ADDENDUM:

***STATE SIGNIFICANT
DEVELOPMENT ASSESSMENT
Warkworth Continuation Project
(SSD-6464)***

Environmental Assessment Report
Section 89E of the
Environmental Planning and Assessment Act 1979
May 2015

Figure 1: Measured low frequency noise spectra compared to modified DEFRA curve

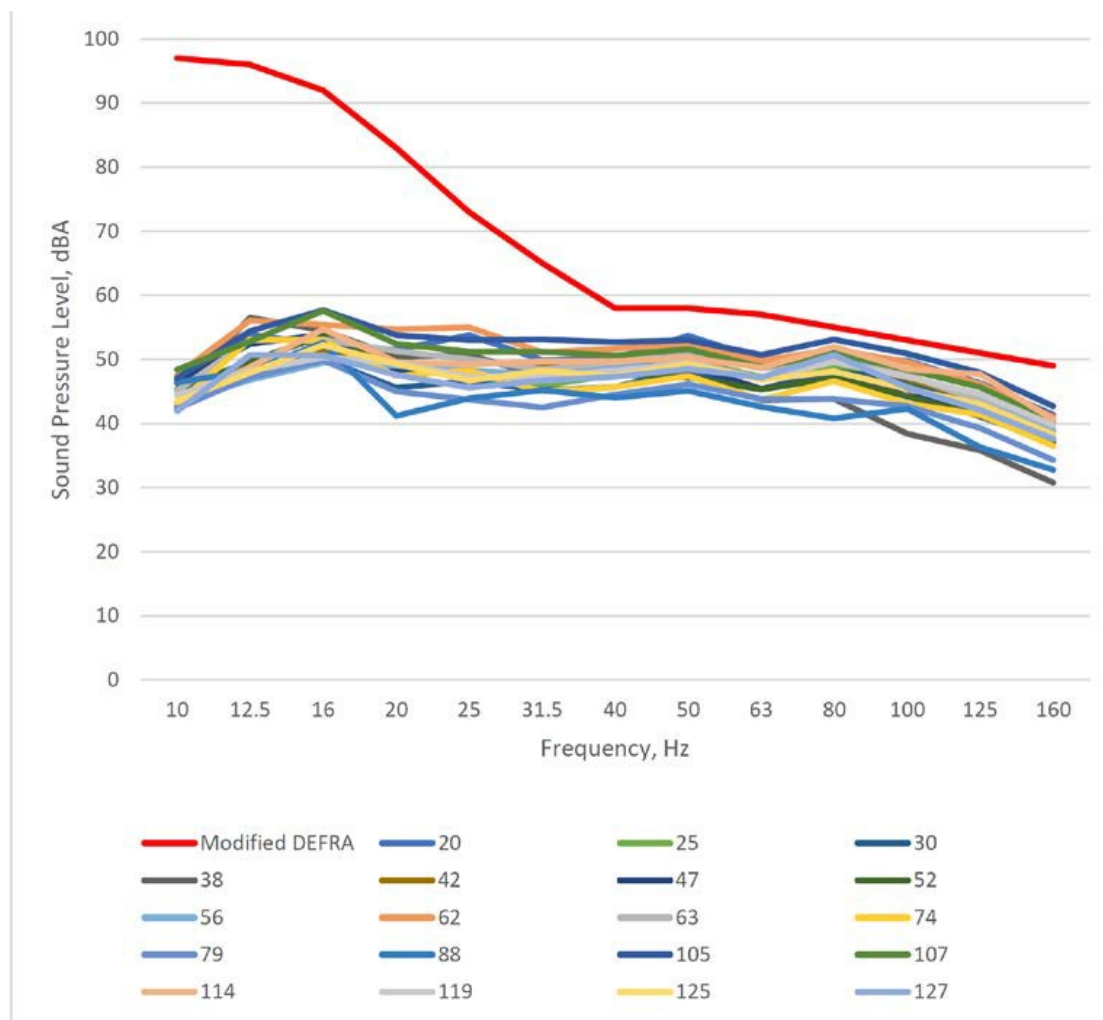
The audit indicates that C – A levels do exceed the 15dB threshold levels at all of the monitoring locations in Bulga Village. However, the LFN levels were found to comply with the modified⁴ DEFRA curve thresholds at all receivers. An example of the monitoring results against the modified DEFRA curve at one of the key residences in Bulga is shown in Figure 1 below.

However, given the limitations of the current approach outlined under the INP, the Department has amended the recommended conditions (Appendix 7 of the conditions) to clarify that the modifying factor for LFN is to be applied, except where it can be demonstrated that this is only as a result of differential attenuation over distance.

Figure 2: Options for Partial Filling of Overburden Emplacements Gap

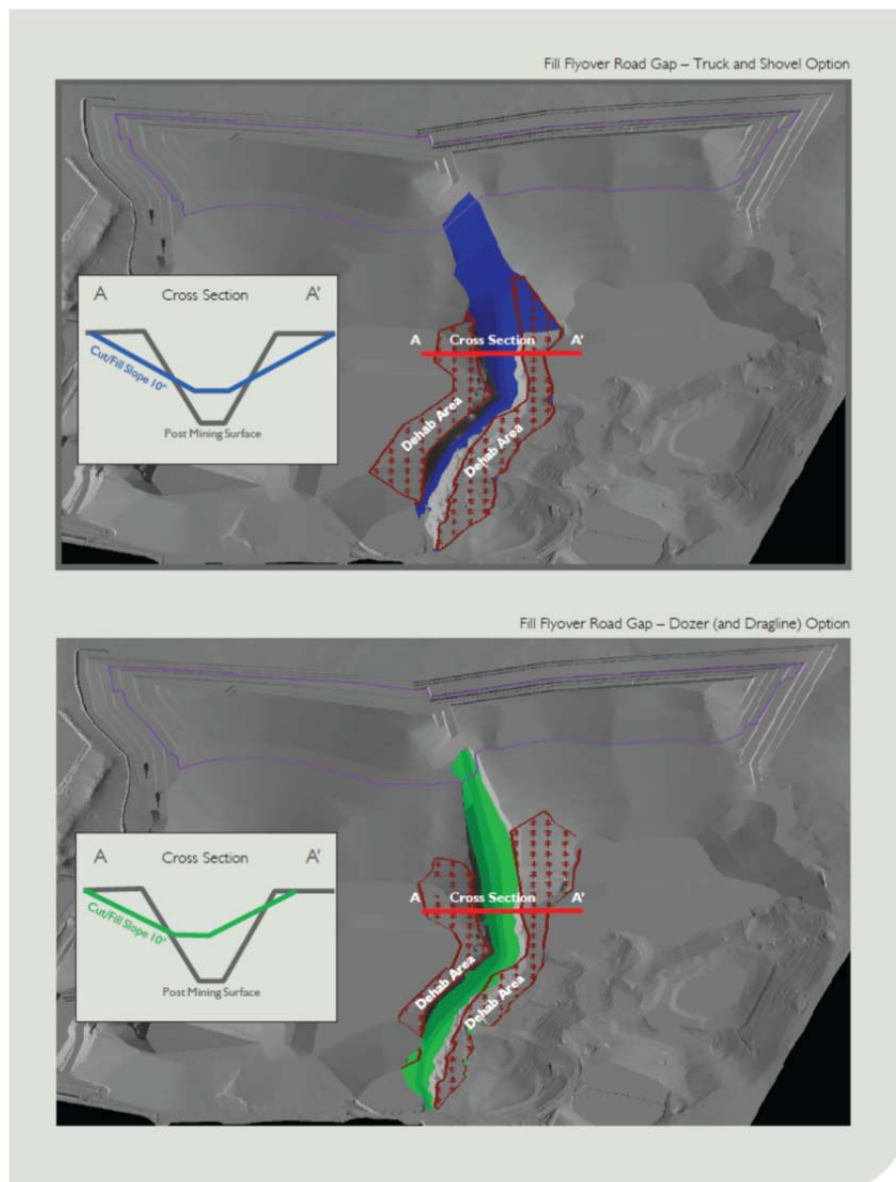
With regard to filling the gap between the two main overburden emplacements, Warkworth has considered two options for undertaking this work (with Option 1 using truck and shovel to undertake the work and Option 2 using a dozer – see Figure 2 below).

The options would result in relatively similar benefits, with Option 2 found to be considerably cheaper to implement and requiring less disturbance of rehabilitated areas. The Department has amended the recommended conditions to reflect this commitment (see condition 56 of schedule 3).
